Access Compliance Report

Public Rights-of-Way

Intersection ID: 30575	Main Street: CIRCLEGREEN_DR	Cross Street: GROVE_CREEK_LN	Location: NE
ADA ID: 022C51033BF2	Ramp Type: PerpDiag	Initial Pass/Fail: Fail	Overall Compliance: No
		Severity Score: 12.5

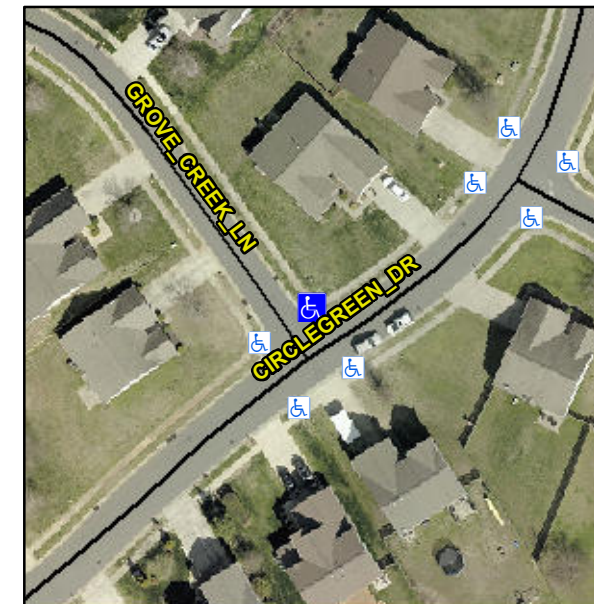
R304.2.2

Compliance	Description	Data	Compliance	Description	Data
N/A	Ramp Length (in)	51.0	No	Ramp Slope (%)	8.6
Yes	Ramp Width (in)	48.0	Yes	Ramp XSlope (%)	0.6
N/A	Flare Type LT	N/A	N/A	Flare Type RT	N/A
N/A	Flare Slope LT (%)	N/A	N/A	Flare Slope RT (%)	N/A
N/A	Flare Traversable LT?	N/A	N/A	Flare Traversable RT?	N/A
N/A	Landing Length (in)	N/A	N/A	DWS Provided?	N/A
N/A	Landing Width (in)	N/A	N/A	DWS Contrast?	N/A
N/A	Landing Slope (%)	N/A	N/A	DWS Length (in)	N/A
N/A	Landing X Slope (%)	N/A	N/A	DWS Full Width?	N/A
N/A	Landing Curb? (Y/N)	N/A	N/A	DWS Offset (in)	N/A
N/A	Shared Landing?	N/A			
N/A	Gutter Ponding?	N/A	N/A	Gutter Slope (%)	N/A
N/A	Gutter Lip Ht (in)	N/A	N/A	Gutter X Slope (%)	N/A
N/A	Painted X Walk1?	No	N/A	Painted X Walk2?	No
	X Walk 1 Direction	To SW		X Walk 2 Direction	To SE
N/A	X Walk 1 Width (in)	N/A	N/A	X Walk 2 Width (in)	N/A
	X Walk 1 Slope (%)	2.2		X Walk 2 Slope (%)	1.8
	X Walk 1 X Slope (%)	2.4		X Walk 2 X Slope (%)	0.7

Remove & Replace Curb Ramp With Two New Directional Ramps or Equivalent.
